UNITED STATES PATENT AND TRADEMARK OFFICE

10/529,597

Office Action Summary	Application No. 10/529,597	Applicant(s) KAUPPINEN, JYRKI	
	Examiner JONATHON D. COOK	Art Unit 2886

Detailed Action

(Modified figure 2)

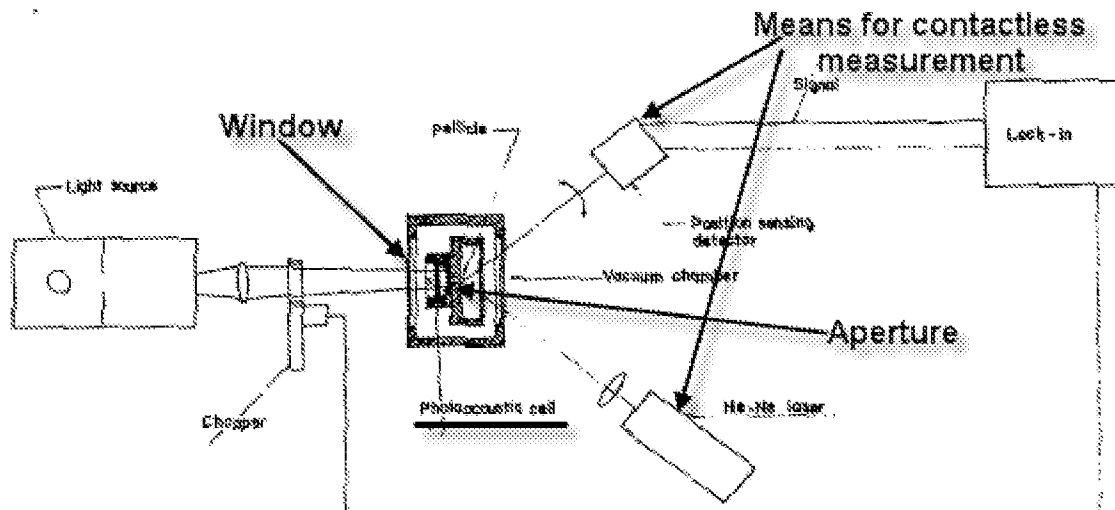
Regarding **Claim 16**, de Paula discloses and shows in **fig. 2** a microphone for photoacoustics, comprising:

a photoacoustic cell (applicant's first chamber) suppliable with a gas to be analyzed;

a window for letting modulated and/or pulsed infrared radiation and/or light in the first chamber (see modified figure 2);

an duct (applicant's aperture) provided in the wall of the first chamber, in communication with which is provided a pellicle (applicant's door) adapted to be movable in response to movement of a gas (see modified figure 2);

mounting the pellicle slightly laterally displaced in relation to the duct so that one side of the pellicle touches the border of the duct (applicant's door being at least on one side mounted on a frame structure encircling side faces of the door, as discussed above)(**Section II, 2nd paragraph**).

a means for contactless measurement of the door movement (see modified figure 2);

(Modified figure 4)

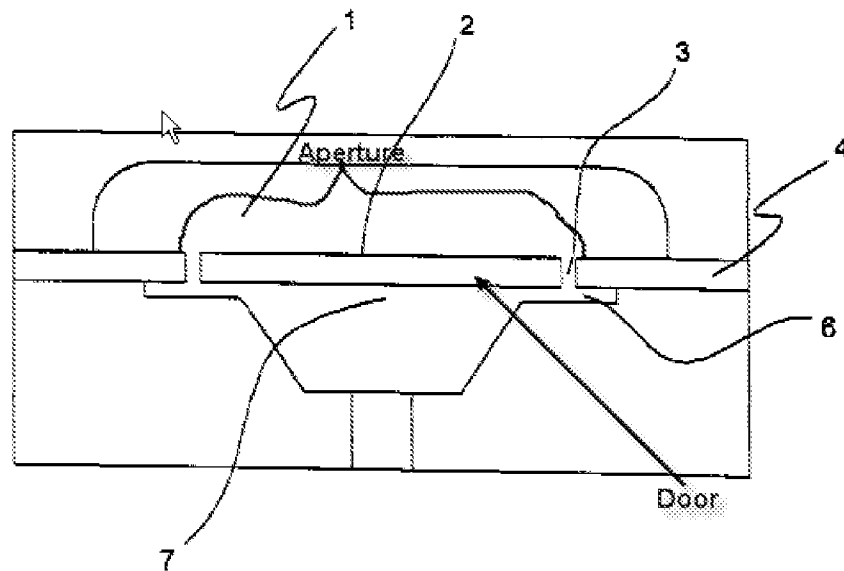
However, Meringdal teaches and shows in **fig. 4** a sensor diaphragm (**2**) which is slightly smaller than the aperture (see Modified figure 4).

Therefore, it would at least been obvious to one of ordinary skill in the art at the time the invention was made to modify the invention of de Paula with the door has a surface area which is at most equal to the surface area of the aperture because it will allow for freedom of movement of the door, which will not be brushing against the side of the aperture, and therefore provide better sensitivity to vibratory impulses due to pressure shifts.
